REGIONAL REVIEW NOTIFICATION

RE: Development of Regional Impact Review

Name of Proposal: Bowen Homes Redevelopment DRI 4036

<u>Description:</u> A DRI review of a proposal to construct a mixed-use project with 37 single-family units, 1,963 multi-family units, 60,000 SF of retail space, 20,000 SF of office space, and 25,000 SF of community center space on a 74-acre site of the former Bowen Homes housing development of Donald Hollowell Parkway and James Jackson Parkway in the City of Atlanta.

2105019 OVERALL SITE PLAN

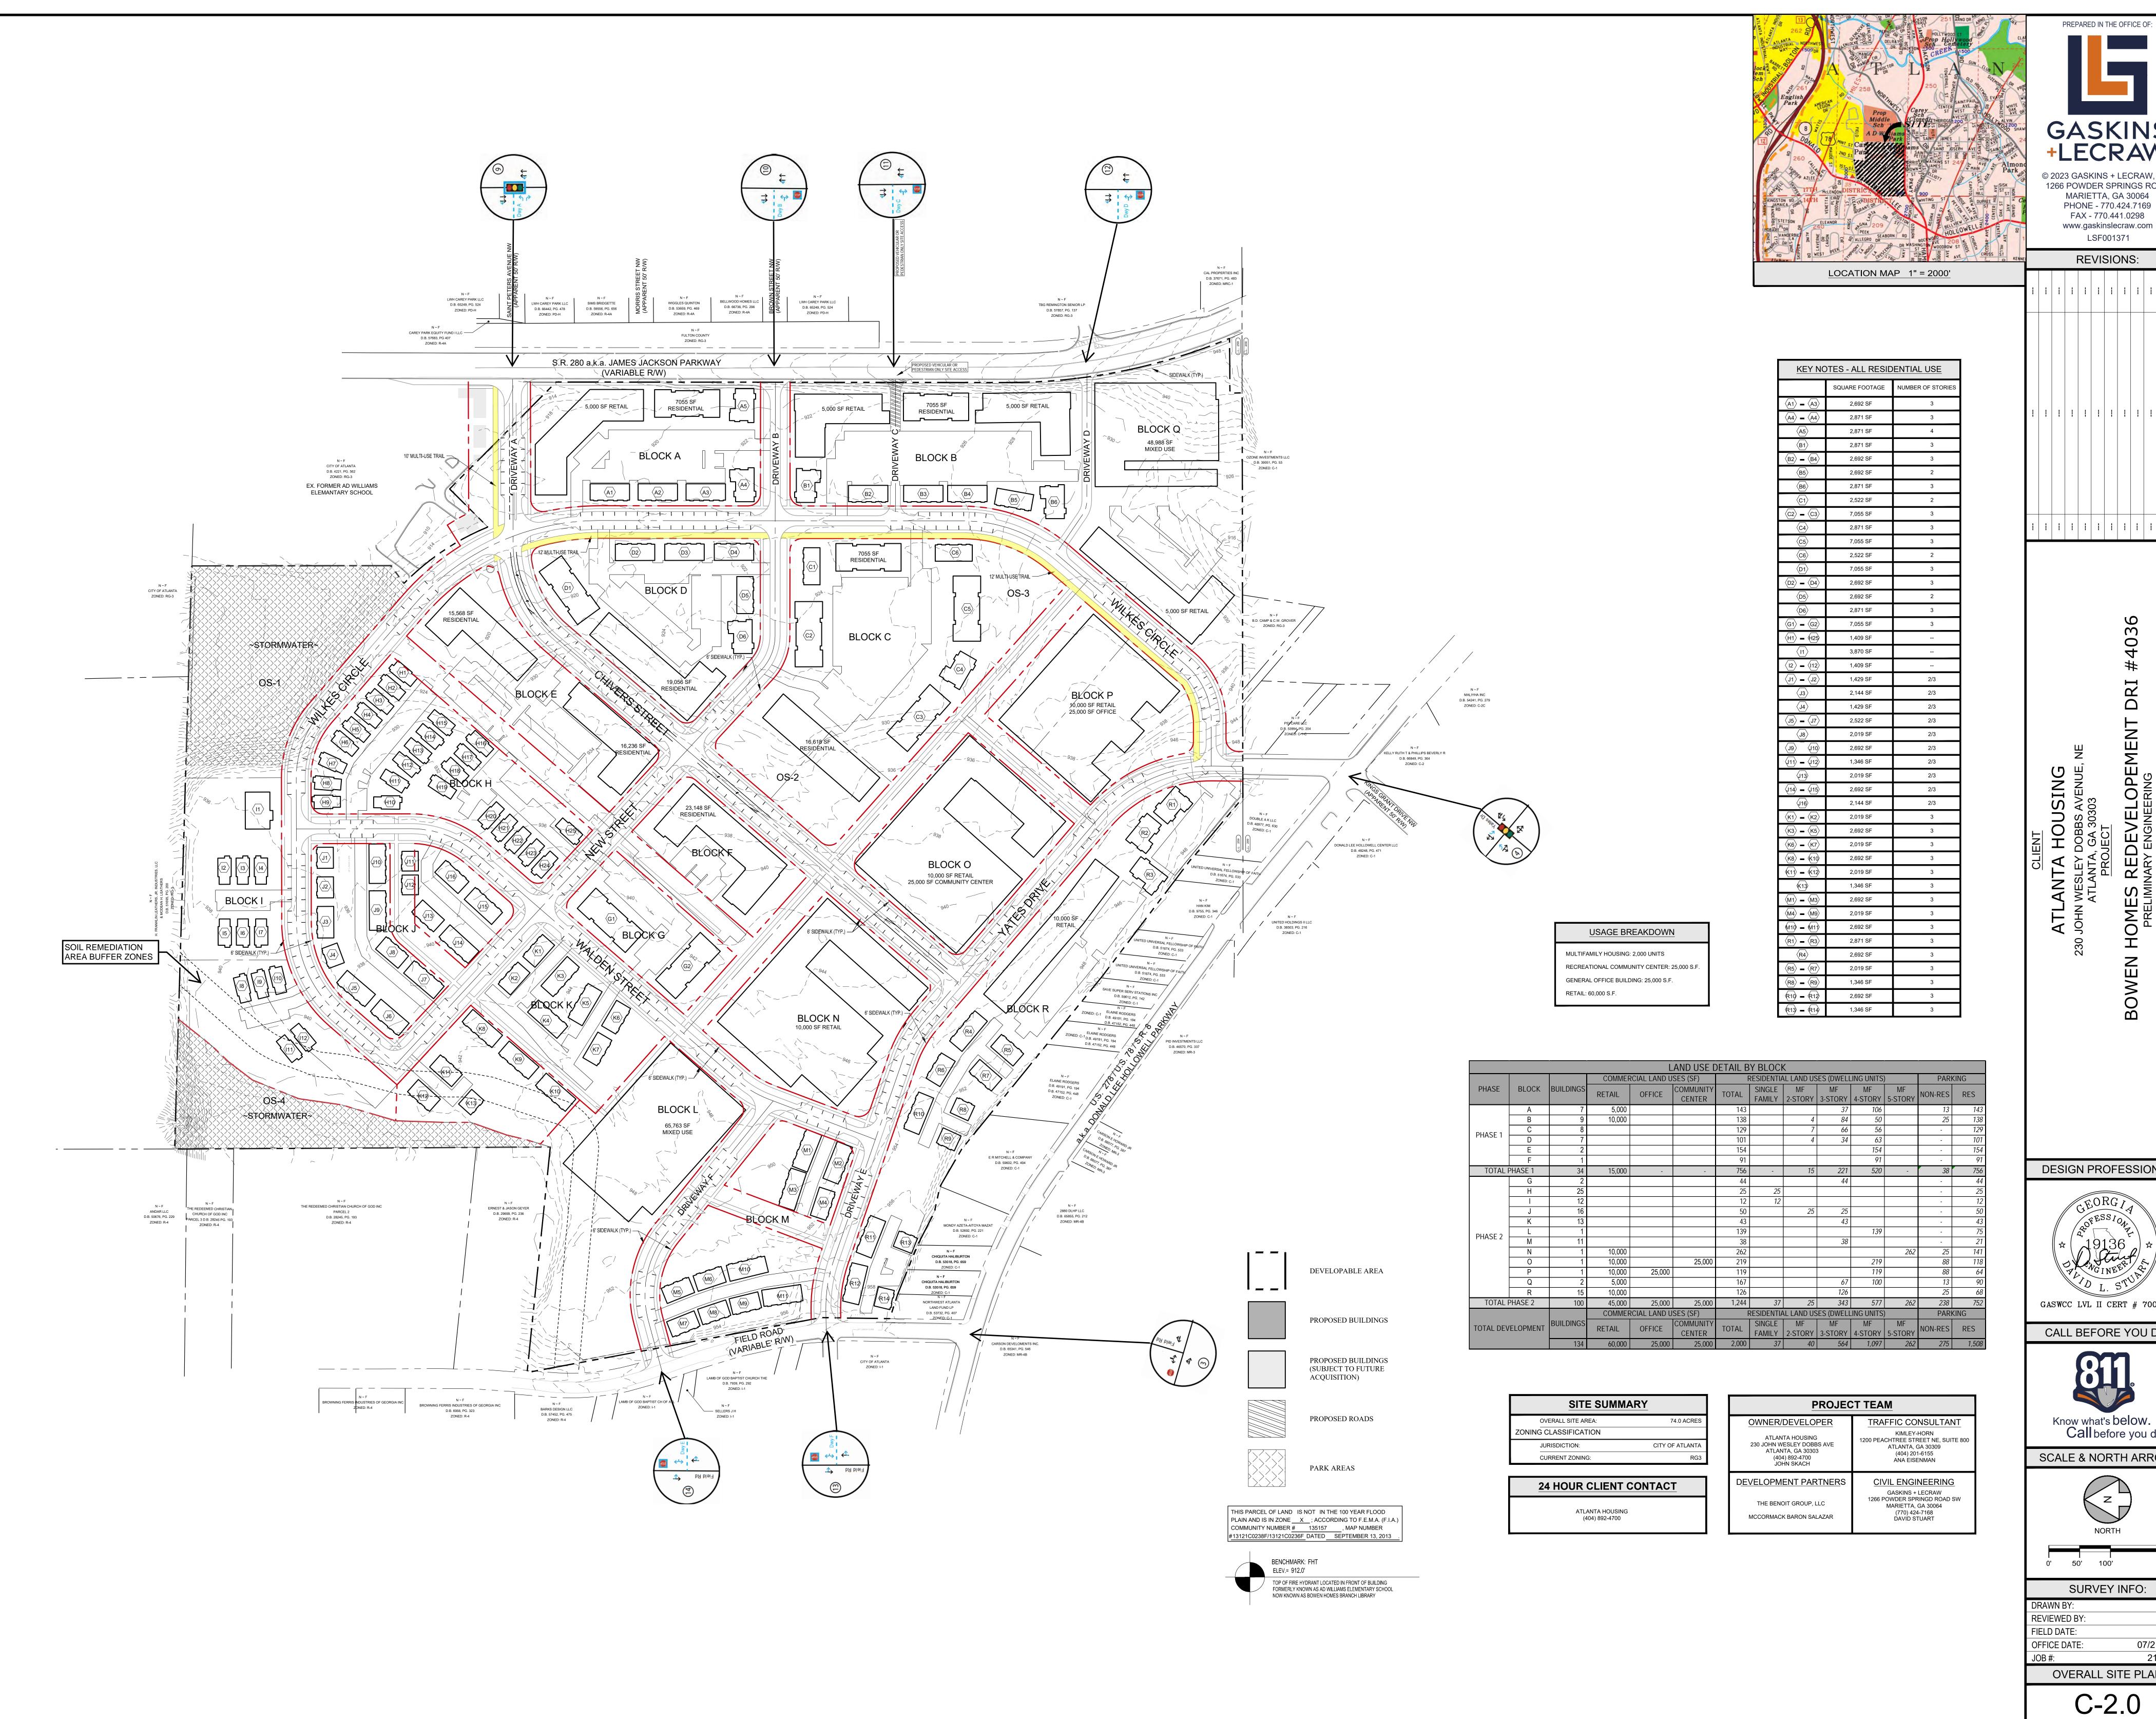
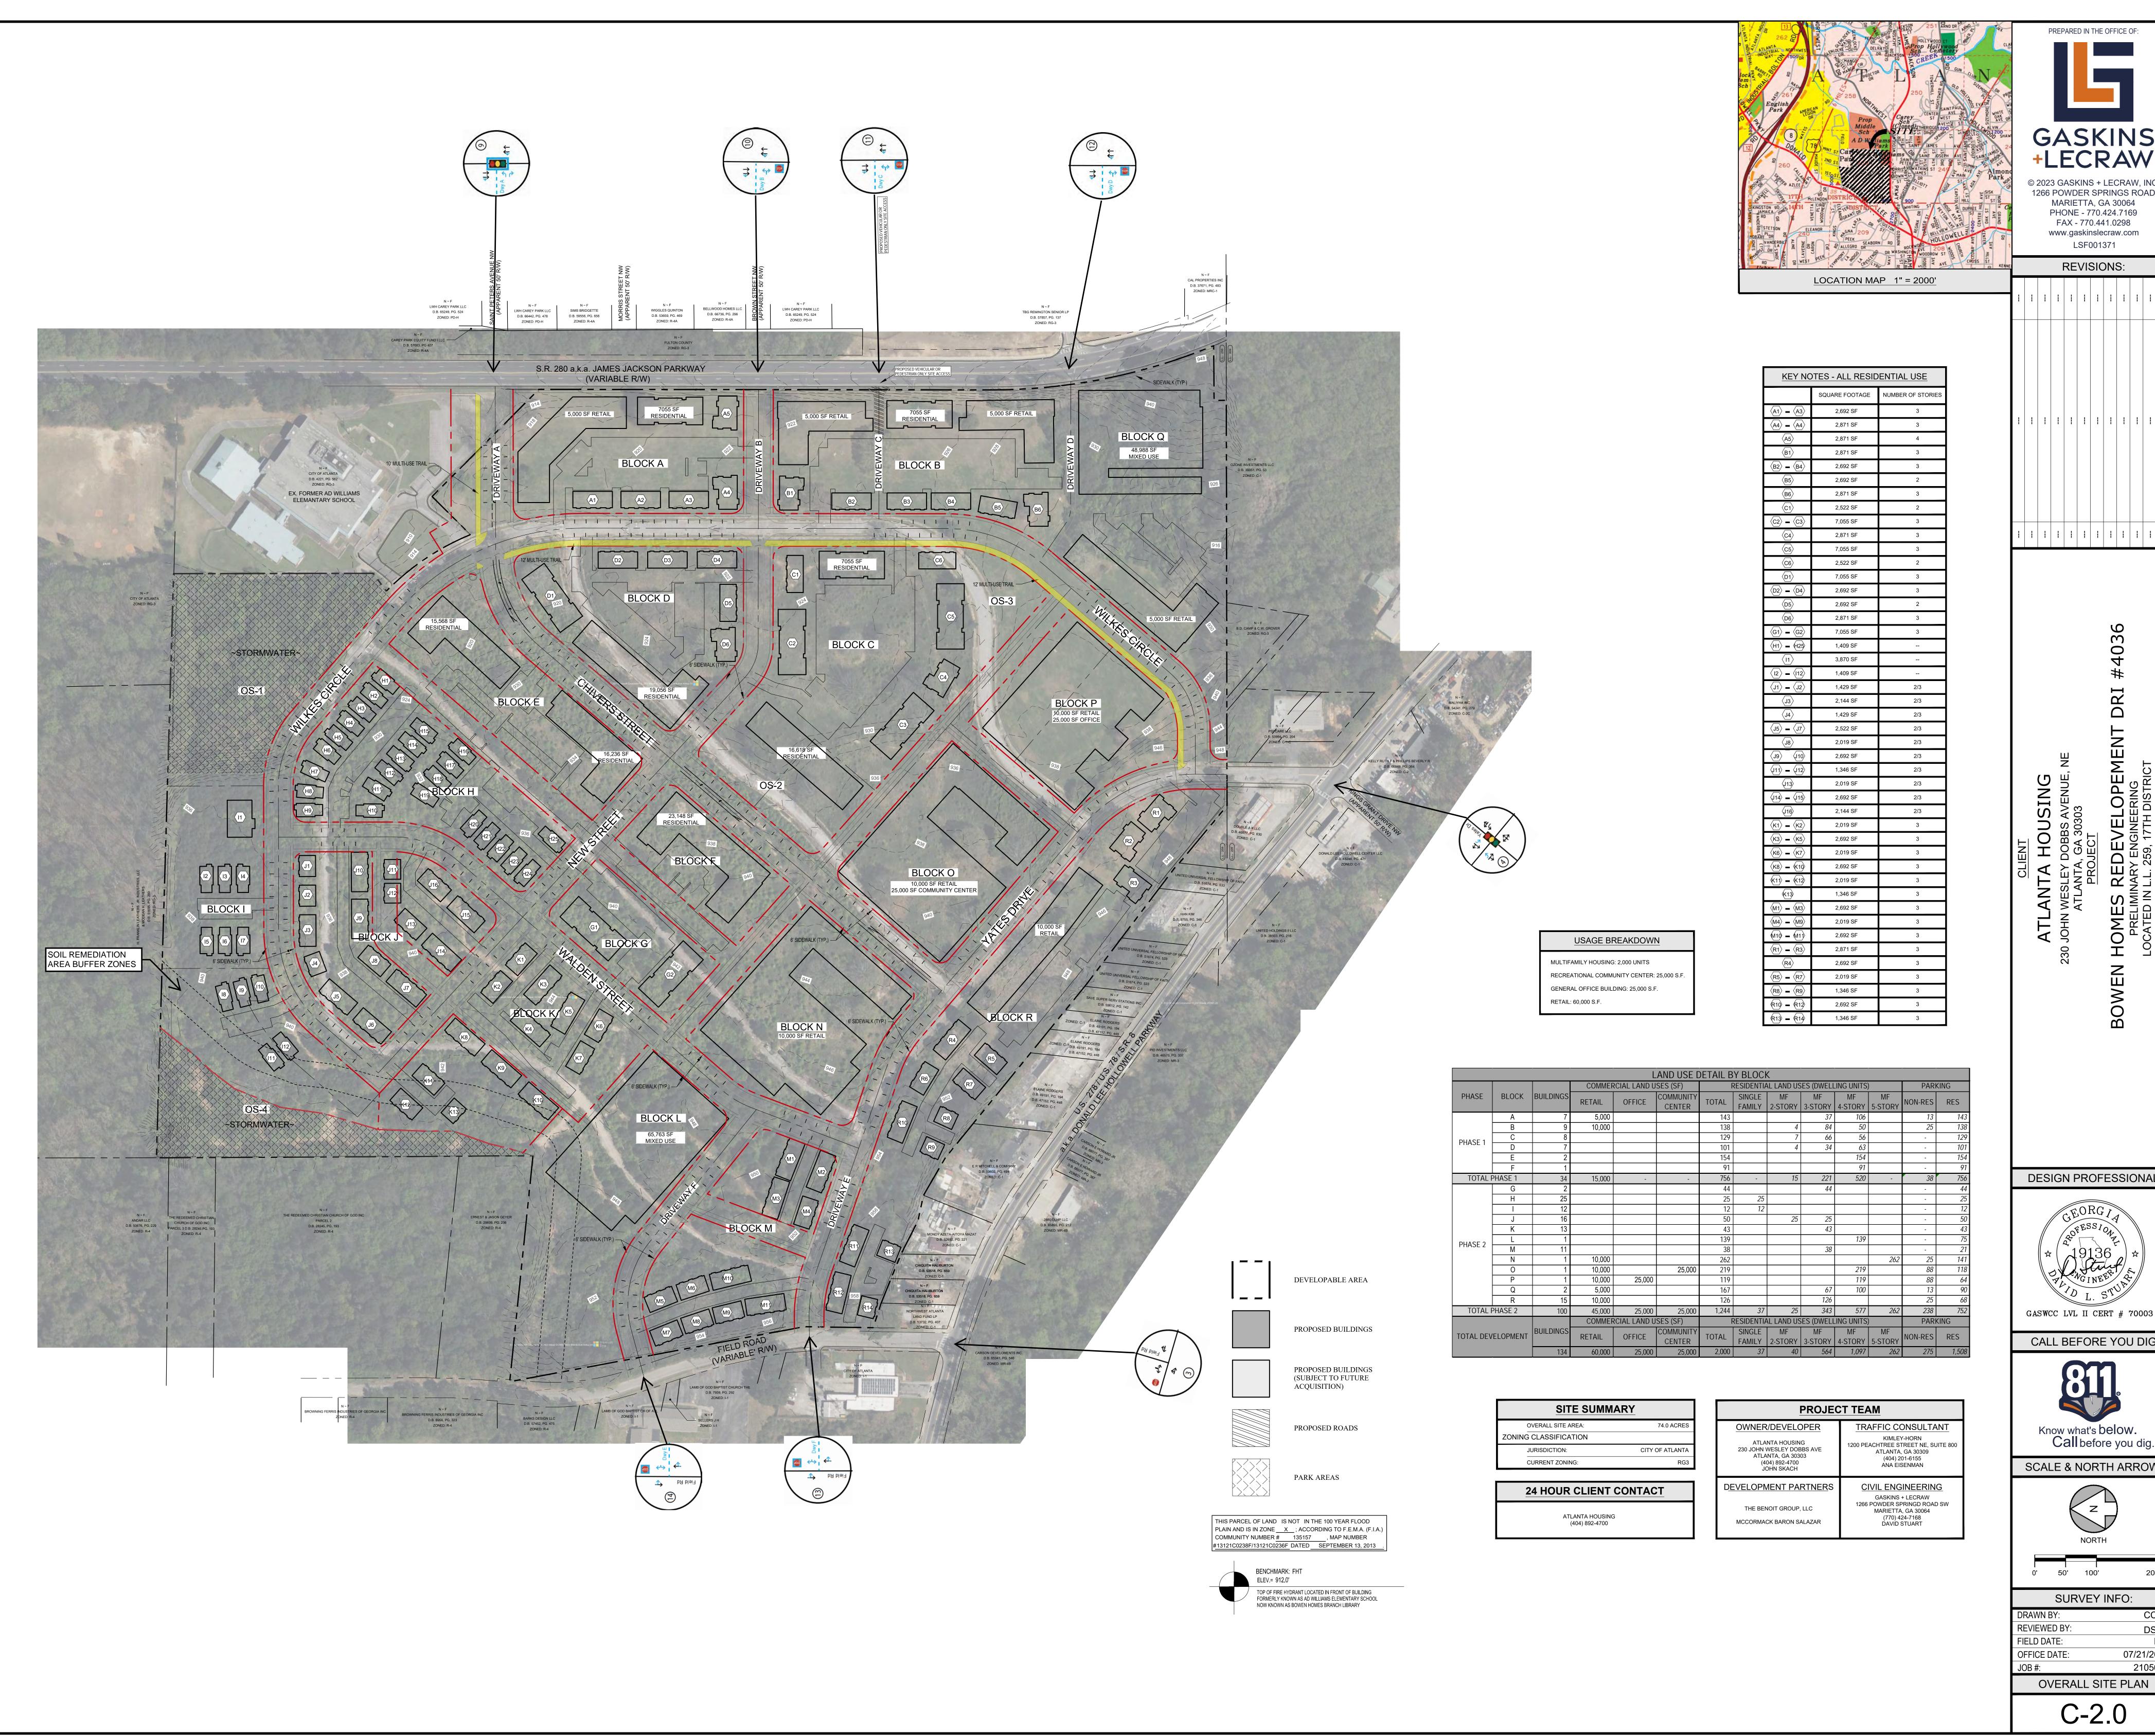
The project's provision of a robust sidewalk network and multi-use internal trail are supportive of regional multi-modal transportation policies. The route of the proposed multi-use trail appears to skirt the center of the development. A more central route along Chivers Street would provide much stronger connectivity to the full project. The project website mentions that the "A.D. Williams Creek Trail will connect to the residential development and surrounding community assets." but this component does not appear in the project materials. Connection of the project to a larger regional trail would substantially enhance its multi-modal transportation connectivity.

A total of 1,783 parking spaces are proposed in a mix of on-street and structured parking facilities. Plans do not appear to identify EV charging spaces or bicycle parking spaces; optimal amounts of both would be supportive of regional multi-modal and transportation electrification policies.

The site plan shows above–ground stormwater facilities taking up much of the remaining wooded open space of the site. Alternative stormwater approaches – including green infrastructure and underground storage vaults – to reduce the need for these facilities would allow the retention of more trees which in turn reduces stormwater generation and cools the air. The project website notes that "A pedestrian green street and linear storm water park connects through the site east to west, creating green infrastructure to reduce flooding." but these elements are not shown on the site plan. Inclusion of these measures would be highly supportive of regional stormwater and environmental policies.
